# Notes from visit by Ruth Todd, architectural historian

## 353 N. Claremont Street

July 17, 2014

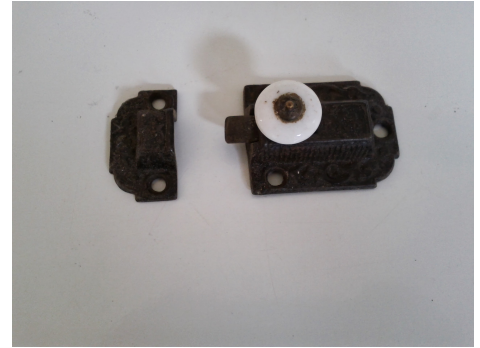
- Do you think the fireplace hearth and mantel are original? Do you think the back wall of the firebox is original? [She thought our assessment was plausible, that the hearth and mantel are original.]
- Do you think the bin-pull handles and cupboard latch we have belong to the dining room cupboard? [Yes, for both the bin pulls and the cupboard latch.]

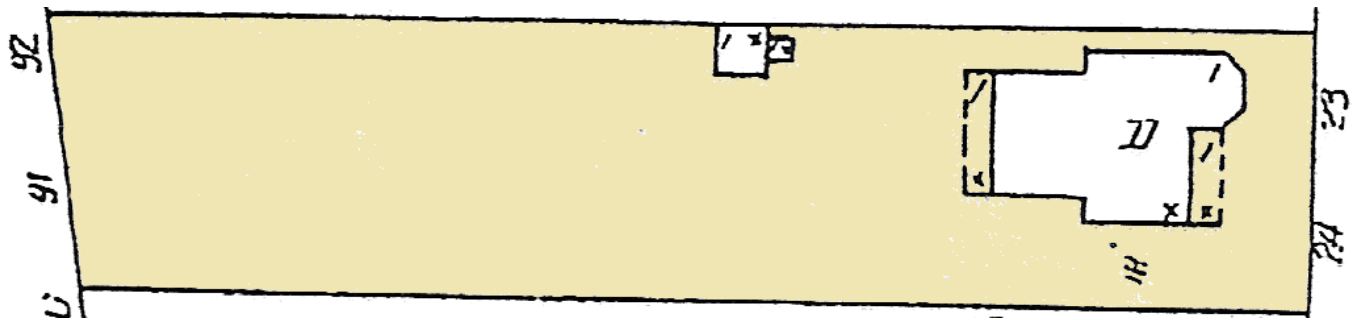
- Would you recommend installing a fire sprinkler system, or is that likely to do as much harm as good? [This is more common in larger public buildings.]
- In the California Historical Building Code, in the chapter on Fire Protection, they talk about wood lath and plaster walls, and discuss filling interior walls with “mineral fiber or glass fiber.” Would you recommend doing that? Is that something we could consider doing for exterior walls as well, or is that not possible? [We could put in bat insulation, which is mostly used for thermal insulation but which might help slow the spread of a fire.]
